NEUBERGER HALL

Type III Design Review Submittal | May 19, 2017 (REVISED July 21, 2017)

PORTLAND STATE UNIVERSITY

DESIGN ADVICE REQUEST COMMENTS - RESPONSE

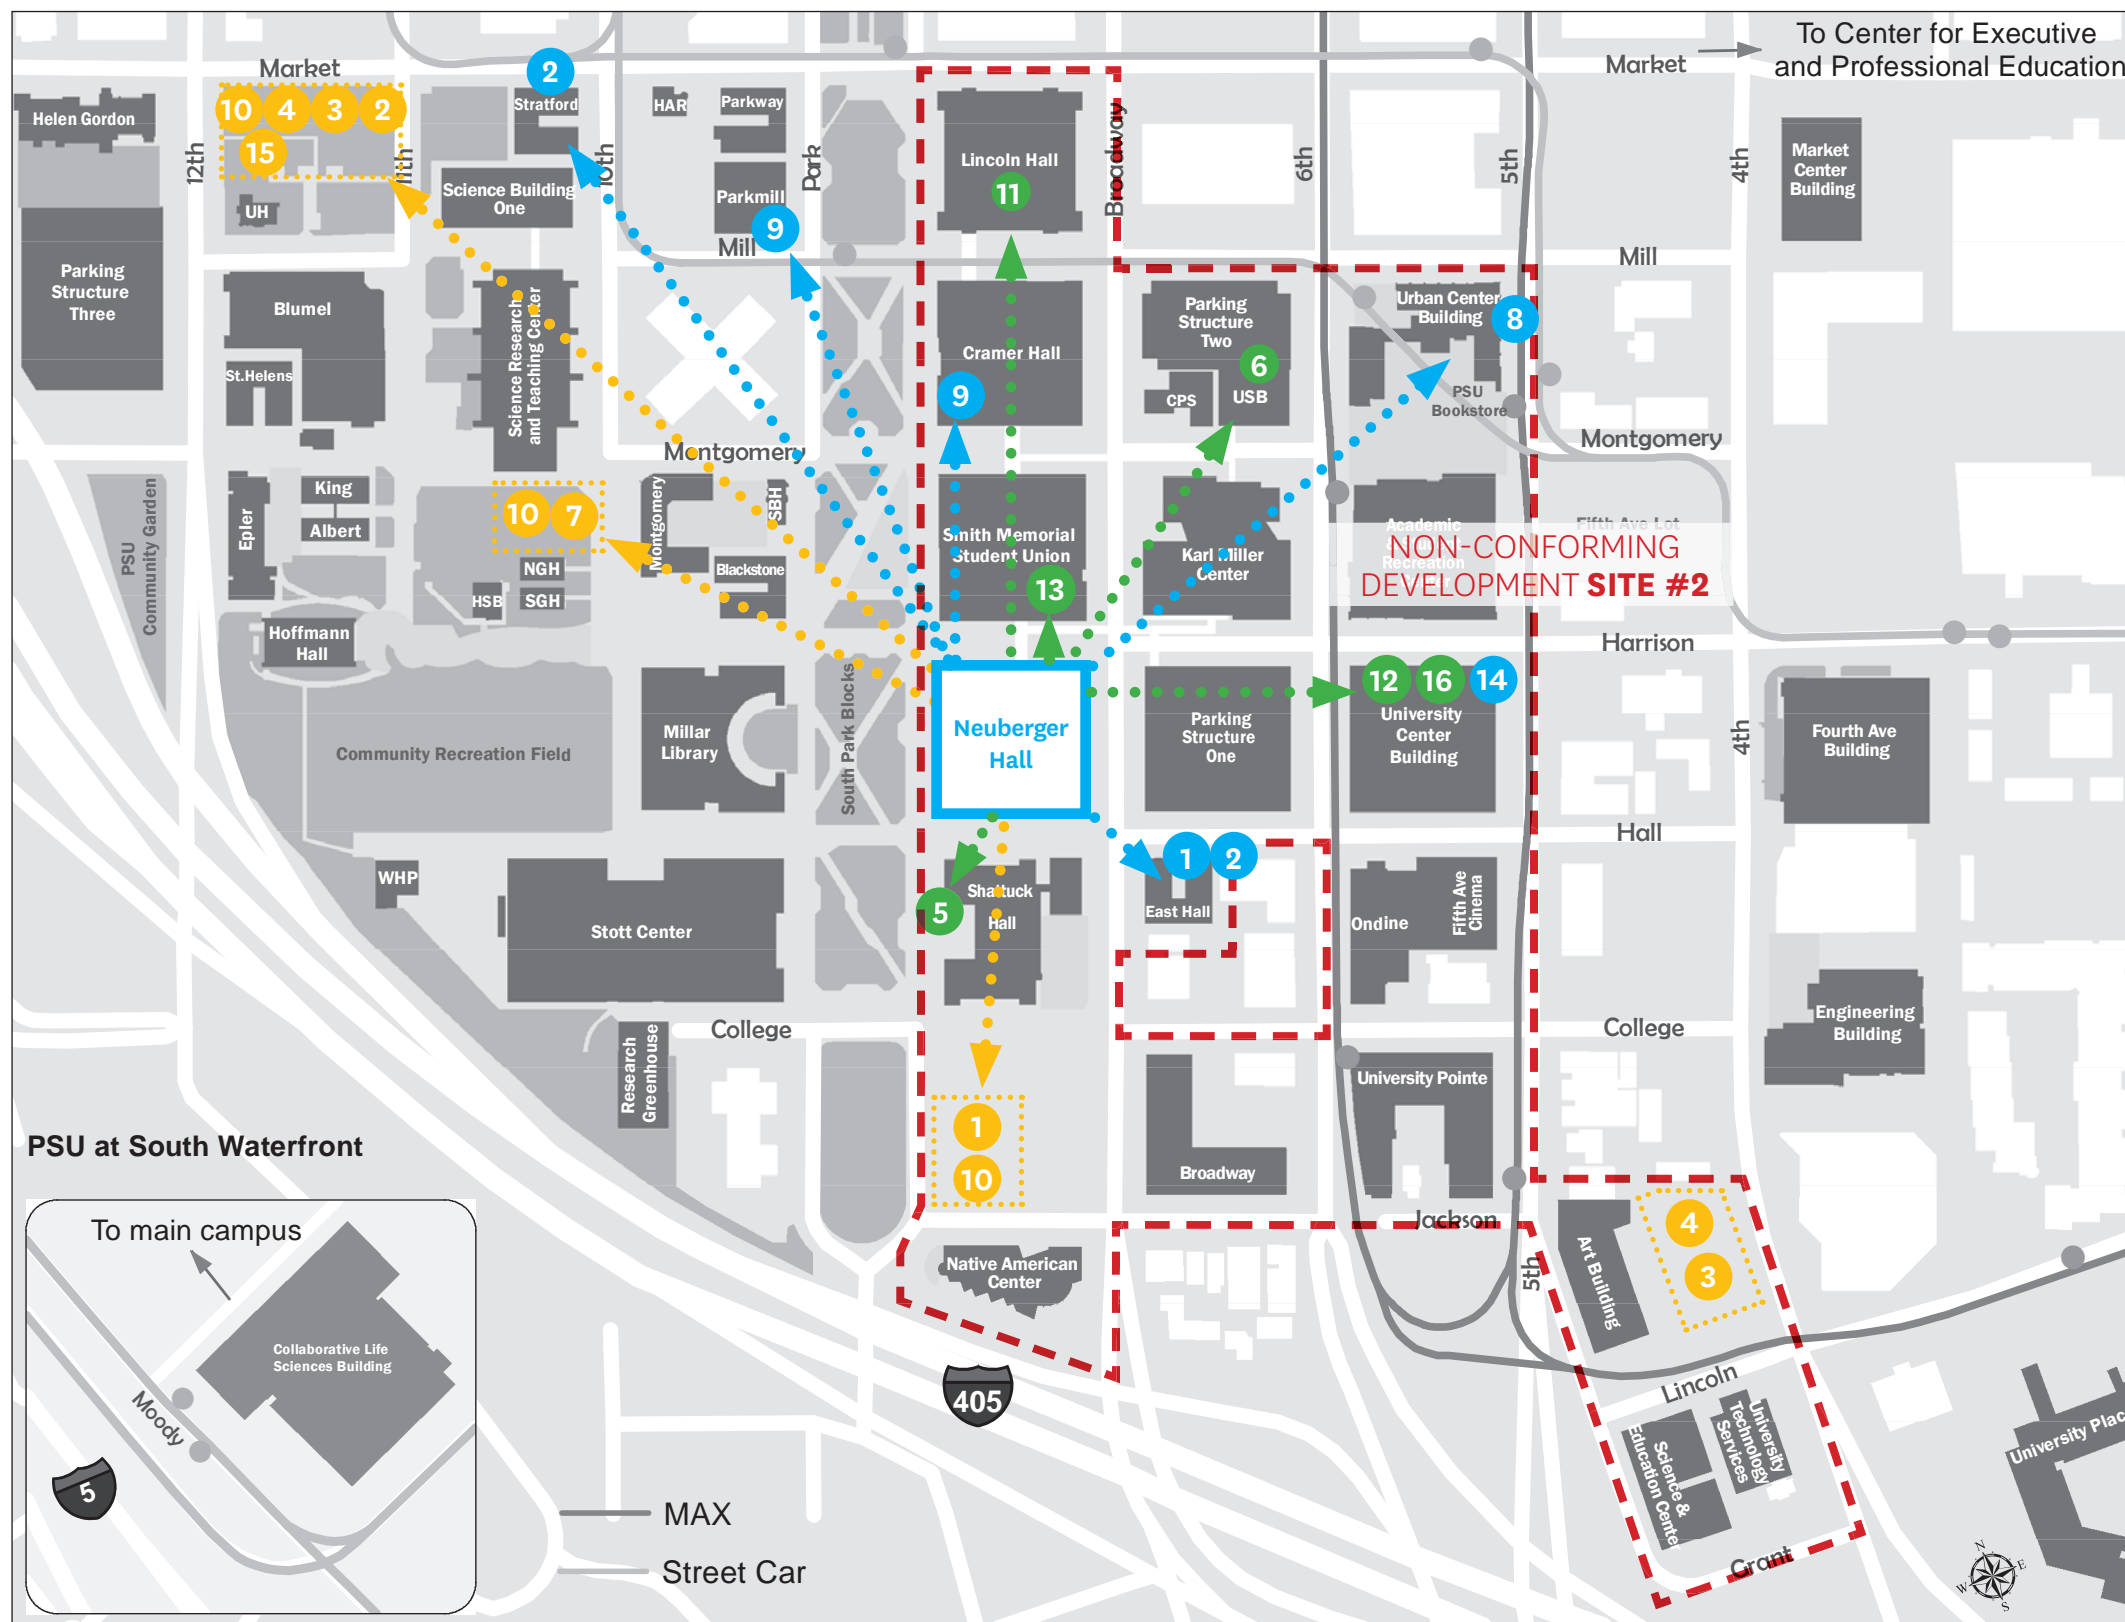
- Don’t relegate existing art (Tom Hardy piece) to back of building buried within the campus

The Thomas Hardy sculpture that currently covers the ground level building elevation of the park side, PSU has engaged the estate of Tom Hardy which has approved the relocation plan for the sculpture. This new location will be on the south side of the Science Research and Teaching Center adjacent to an open park area. This new location will allow the sculpture to be experienced up close as intended at Neuberger Hall before the existence of the park blocks.
